REMARKS

Amendments to the Drawings:

FIG. 6b

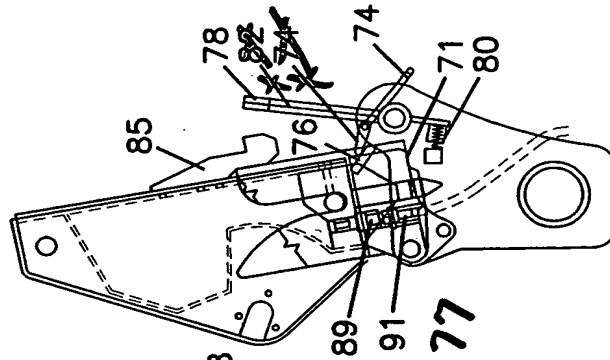
Fig. 6b has been amended to remove the second occurrence of reference number 74.

Fig. 6b has been amended to remove reference number 82.
